## District of Columbia Government Advisory Neighborhood Commission 6A P. O. Box 75115 Washington, DC 20013

Re: Notice to ZA of Potential Zoning Violation (1316 Corbin Place)

Re: 1316 Corbin Place NE Construction

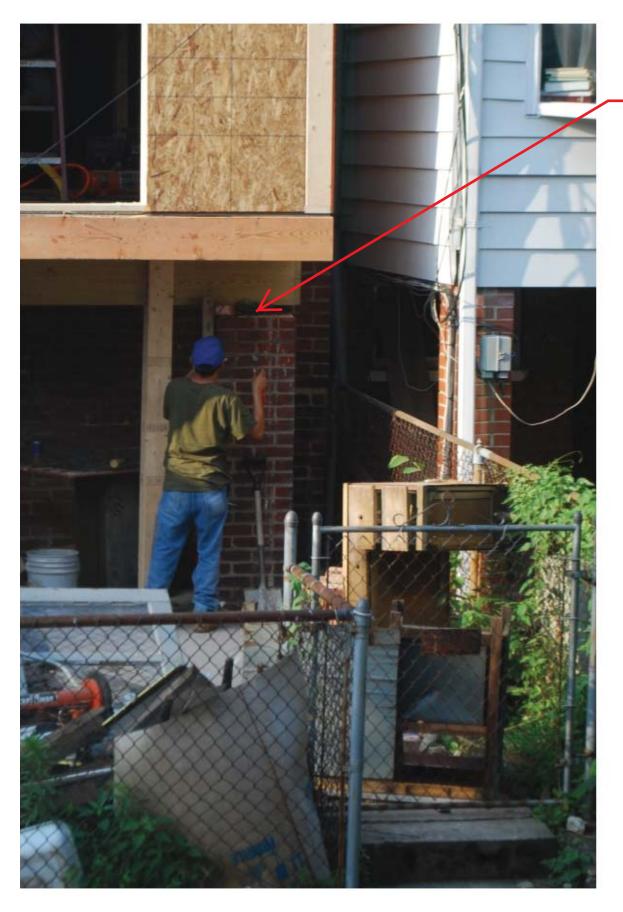
addition was not permitted, exceeds original footprint of porch, boundary survey and wall check were not performed

walls on property lines are not rated construction.

cantilever exceeds acceptable length

1316 corbin place exhibit 1, page 2 photo taken July 15, 2013

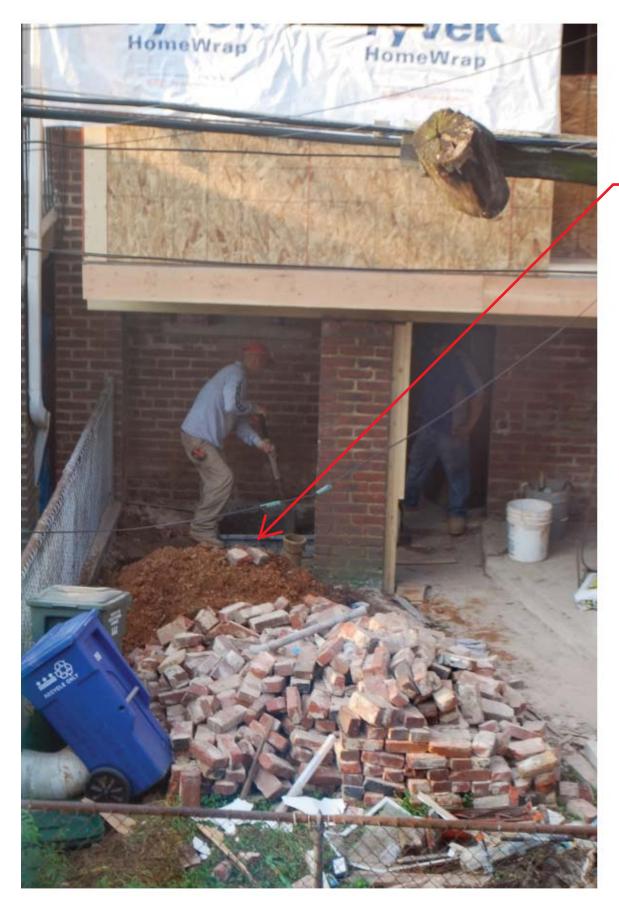
chimney of
adjacent property
(1318 Corbin) was
compromised
during demolition
and covered up
behind new
construction.

entire back wall and all interior walls were completly demolished, well outside the scope of the permit and without informing the neighboring property owners.

brick piers
supporting the
addition were
topped off after the
addition was in
place.

1316 corbin place exhibit 1, page 4 photo taken July 16, 2013

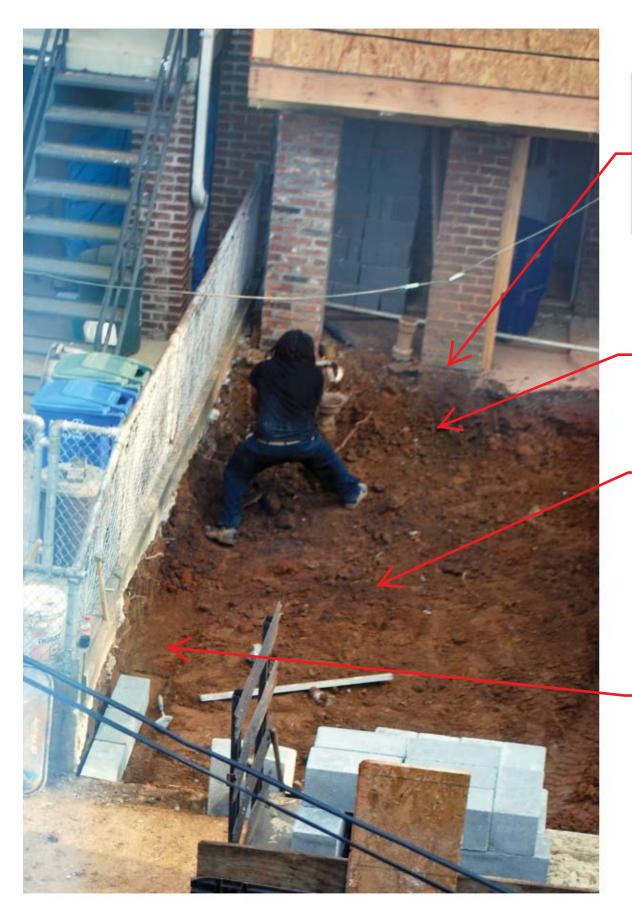
additional footing and pier was constructed (after the addition was in place) without a footing inspection

existing piers
supporting the
addition are sitting
on the slab, which
has been removed
to the face of the
pier. these piers
have no foundation

excavation against all three piers seriously compromises the ability of the piers to support the weight of the addition

entire rear yard was excavated, outside the scope of the permit, and without DDOE oversight.

retaining wall was constructed without a footing. CMU was placed directly on the soil.
